**From:** Diver, John  
**Sent:** 28 February 2017 12:28  
**To:** Planning  
**Subject:** FW: 2 Inverforth Close,2016/6994/P  
**Attachments:** No. 3&4 Inverforth Close together.pdf

**Re: Planning application 2016/6994/P (2 Inverforth Close, London NW3 7EX)**

We would like to make some comments regarding the planning application submitted for the proposed alterations to the adjacent property at no.2, including erection of roof extensions & part single, part two storey rear extension; etc.

**Proposed balcony at no. 3 Inverforth Close**

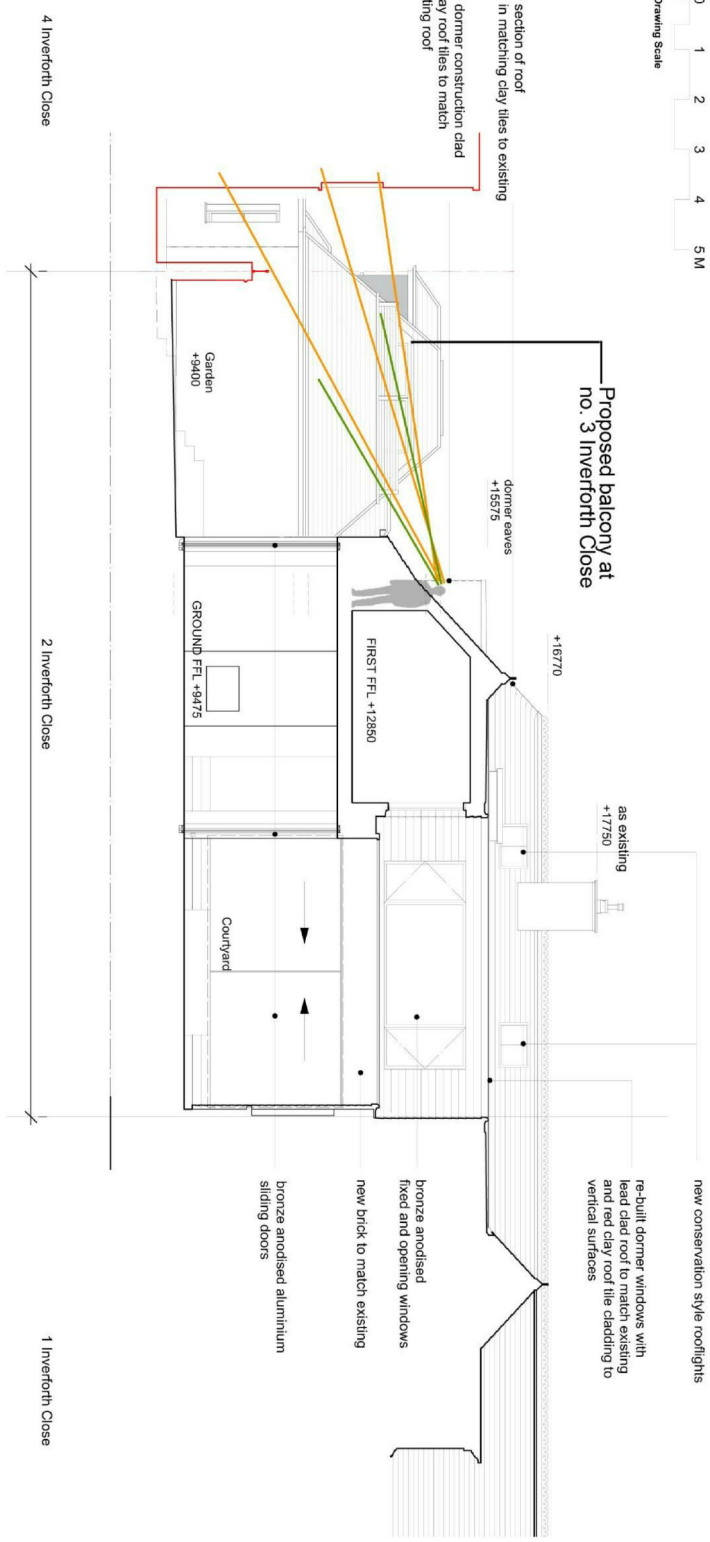
In addition the northernmost proposed dormer with a glazed window of 2.00 meters in length and of 1.20 in height would be overlooking directly into our proposed roof patio depriving us of the privacy and light.

In addition the two proposed dormers where each has a glazed window of 2.00 meters in length and of 1.20 in height would be overlooking directly into the windows of our property such as into the master bedroom on the first floor and the lounge and conservatory on the ground floor.

We would like to point out that on the existing drawing no FP118\_PL008, revision A, the first floor windows of our property are shown whilst it is not shown at the proposed drawing no. FP118\_PL021, revision B. The southernmost proposed dormer would be erected only 6 meters away our eastern wall comprising of our ground and first floor doors and windows.

Please see attached the mentioned proposed elevation with the addition of our property and the indication of the possible overview.

The proposed dormers with their large windows would impact our property even further and we would like to request that they are eliminated.
